Environmental Assessment Covering CIA's Proposed off-site Road Improvements

Environmental Assessment

Route - I23 - Off-Site Road Improvements  
at the C.I.A. Entrance  
Fairfax County

State Project 0123-029-000-C.I.A.  
0219-A002

**ALTERNATIVE 2**  
Route 123/Route 193 CIA Entrance

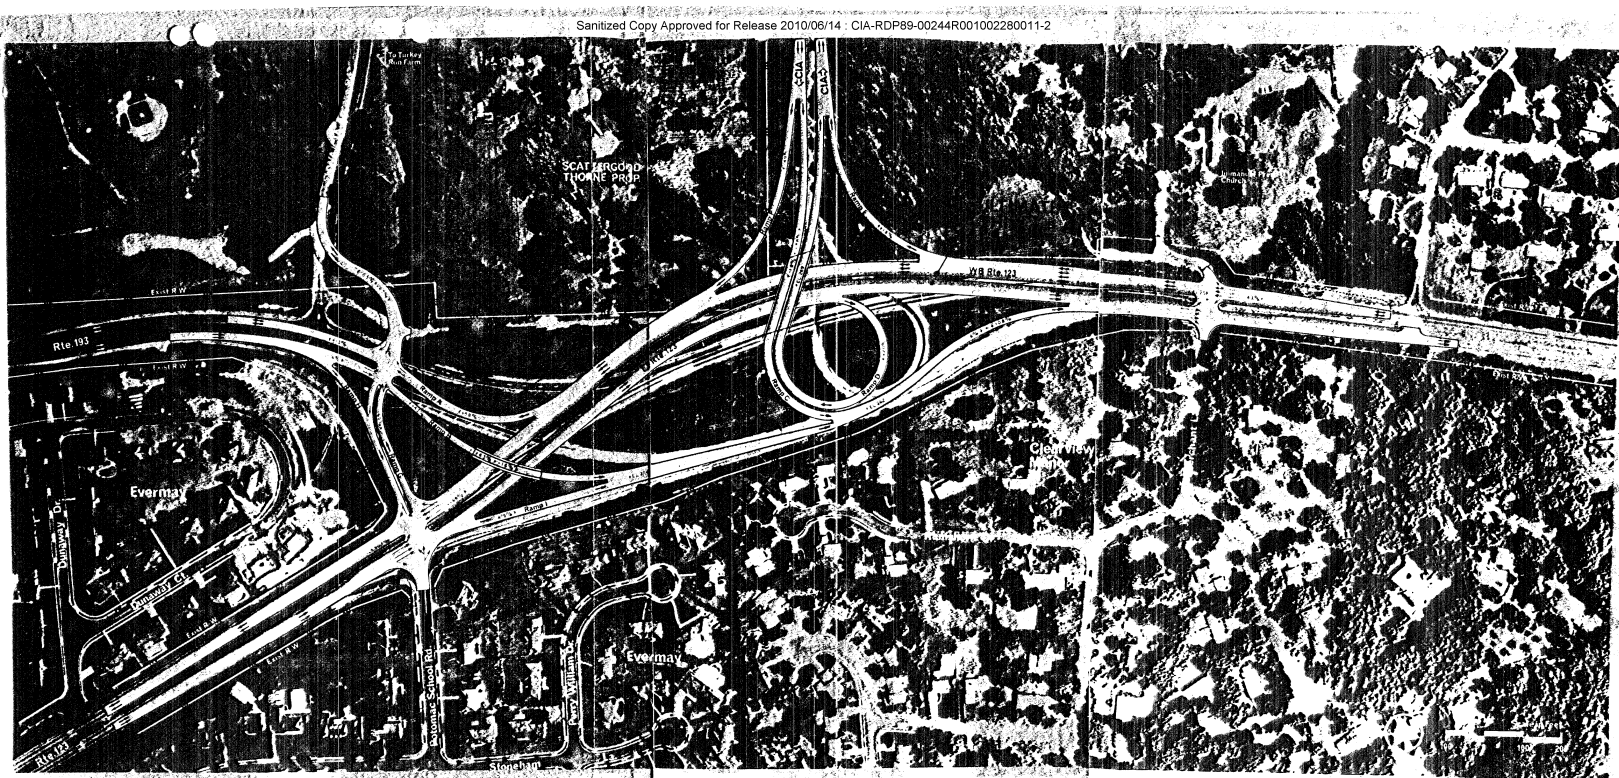
Given that State Route 123 is a major regional highway serving long-distance trips as well as a local roadway serving various communities, Alternative 2 appears to create the best balance of all functional requirements. Alternative 4, on the other hand, appears to create a high-type urban interchange with little consideration of the needs of the local neighborhoods.

A. Support of Alternative 2, the at-grade solution at the Dolley Madison entrance, rather than Alternative 4, the grade-separated solution, with certain conditions:

1. That the CIA build a short asphalt trail which would provide a connection between the sidewalk on the south side of Route 123 and the trail which is to be built on the north side of Route 193.

2. That the two-way section of Potomac School Road-extended be moved slightly to the east to allow space for an earth berm and landscaping between it and Evermay Section 7.

3. That the existing grade between the eastbound and westbound lanes of Route 123 at Potomac School Road be equalized, to eliminate the slope of Route 123 at Potomac School Road which in bad weather is hazardous to school buses and others.

4. That a signal, synchronized with the signal at the main exit from CIA, be provided at the double right turn to Route 123.

5. That the old eastbound pavement bordering Evermay and Clearview Manor be removed and replaced with landscaping for noise control, except for a four-foot wide strip of pavement paralleling the new eastbound lanes which would function as a trail.

It is the clear consensus of the surrounding communities that alternative #2 which provides for an at-grade solution is preferable to alternative #4. We, therefore, support alternative #2 with the following changes:

- a. Route 123 be graded and paved as a four lane road only.
- b. A berm be erected on the east end of Evermay Section 7 such that the Route 193 spur is realigned approximately 60-80 feet east of its present location to facilitate traffic proceeding from Potomac School Road to Route 193 northbound.
- c. The number of lanes on Route 193 at the intersection of Route 193 and Potomac School Road be limited to three - one northbound and two southbound.
- d. A "trip" (or appropriate other) signal be installed at the intersection of Saville Lane and Route 123.
- e. More definitive descriptions of signing and landscaping be provided prior to the conduct of a public informational meeting.

ALTERNATIVE 4  
Route 123 Route 193 CIA Entrance

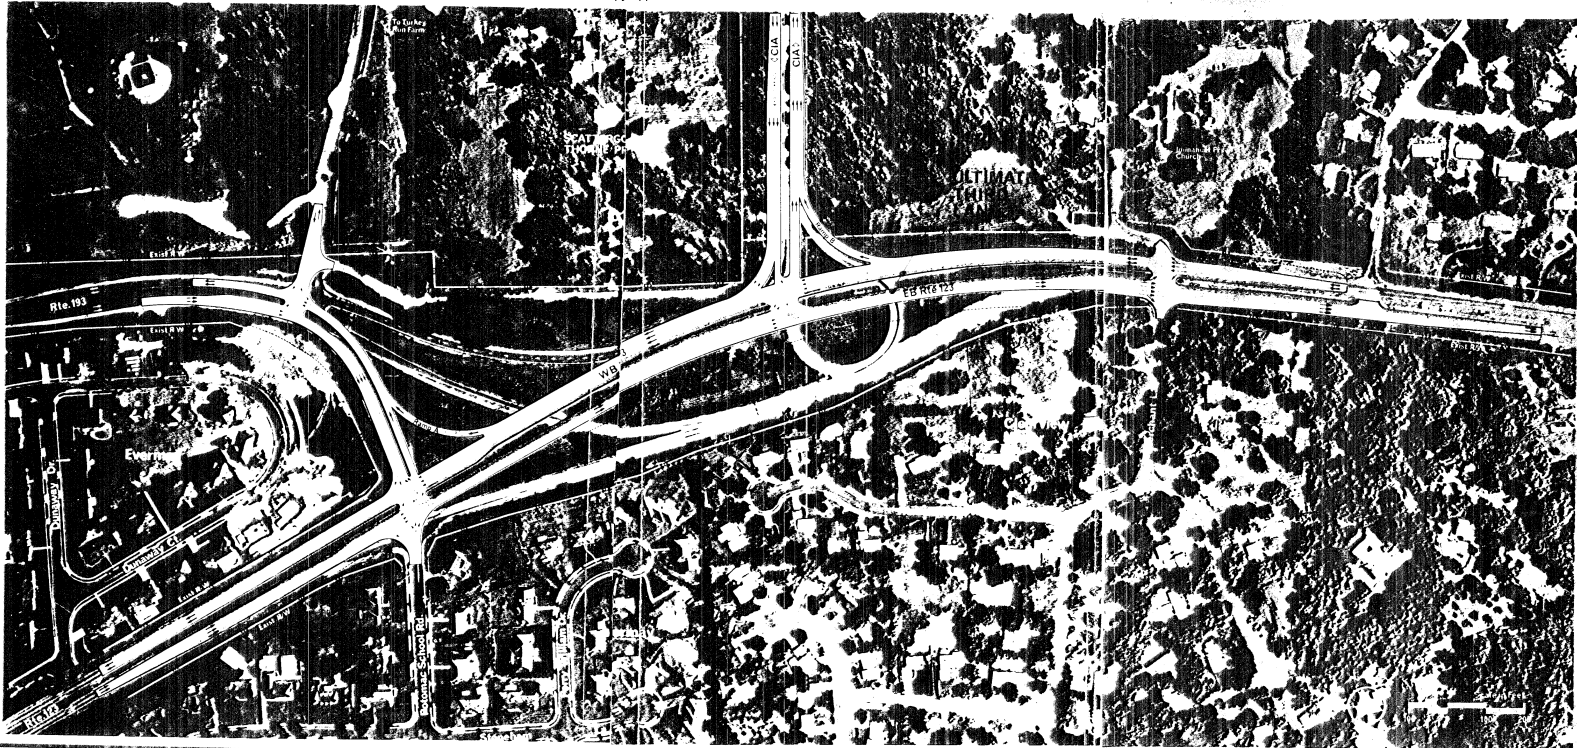
While both alternatives provide what is currently a nonexistent through movement of traffic from Potomac School Road to State Route 193, Alternative 4 does not indicate a through traffic movement from State Route 193 to Potomac School Road. Field observations have indicated that at least 10 percent of total morning inbound Potomac School bus and automobile traffic use this movement.. Denial of this traffic movement may require that rerouting and rescheduling of school buses be performed by Potomac School as well as other schools in the area which currently utilize the Potomac School Road intersection.

Of greater importance, however, is the issue of traffic safety. Alternative 4 requires that traffic desiring to cross State Route 123 between Potomac School Road and State Route 193 must cross six lanes of uncontrolled traffic with approximately 26 feet of "shelter zone" created by the median and the left turn storage bays along State Route 123. This width would permit the storage of one automobile at a time within the "shelter zone" in the event gap time along State Route 123 is not synchronized to allow a continuous movement from State Route 193 to Potomac School Road. However, the majority of buses used by Potomac School, as well as those used by other schools within the surrounding area, are approximately 36 feet in length. Alternative 4 denies the opportunity for a typical school bus driver to utilize a "shelter zone" when desiring to cross State Route 123 and therefore requires him/her to cross six lanes of uncontrolled traffic in one continuous movement.

Furthermore, Alternative 4 would require left turning vehicles to and from Merchant Lane to negotiate seven through lanes of uncontrolled traffic along State Route 123. In addition, poor sight distance at Merchant Lane, as it exists today, will increase the hazard potential to left turning vehicles unless improved by reconstruction. If a traffic signal is not provided at Merchant Lane (serving the Clearview Manor development area) traffic from this area will "drift" toward Potomac School Road in order to more safely access Route 123. This condition will add traffic to Potomac School Road thereby causing greater delay to buses and other vehicles going to and from Potomac School.

Alternative 4 - In this solution our realigned entrance road would penetrate the proposed (realigned) Turkey Run Farm Road at a radius and that may not be desirable. Our entrance road would also have to be extended to meet the new Turkey Run Farm Road. We would request that any expense of extending or realigning our entrance road be borne by the sponsor of these improvements.
